Better Beehive Group Cambridge

BBCG Supplementary Comment 13 January 2025 made following submission of revised planning application documents uploaded on 4 December 2024 on the GCSP planning webpage.

Community visualization of the Beehive proposals (23/03204/OUT. View from northwest showing Silverwood Close properties in green.
Images are for demonstration purposes only however they have been produced using Sketchup and we believe them to be technically and proportionally correct.

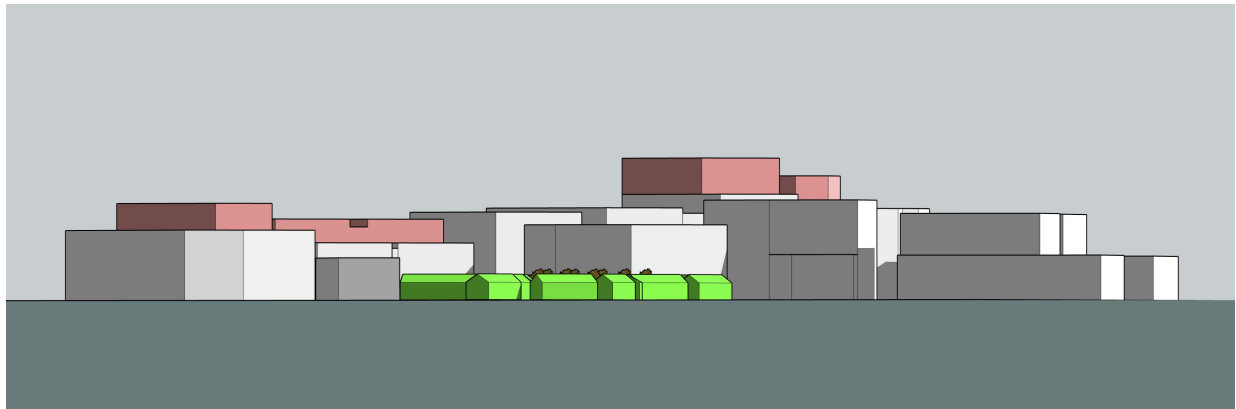
Our concern is that this approach simply sets up future opportunities for too much flexibility, together with too little concern for neighbours, and the continued pushing for as much floor space as possible, especially as the BRE standards for sunlight and daylight is a document for guidance only. We can quite see that the height and massing will remain as shown in the outline parameter plans and the overshadowing of neighbouring houses and gardens will become reality in a few years.

We would reason that there remains a fundamental flaw in the overall design and layout of the Beehive site contrary to Cambridge Local Plan policies, i.e. the site continues to be over developed, with too numerous, overly large buildings, far too close together and too close to domestic dwellings.
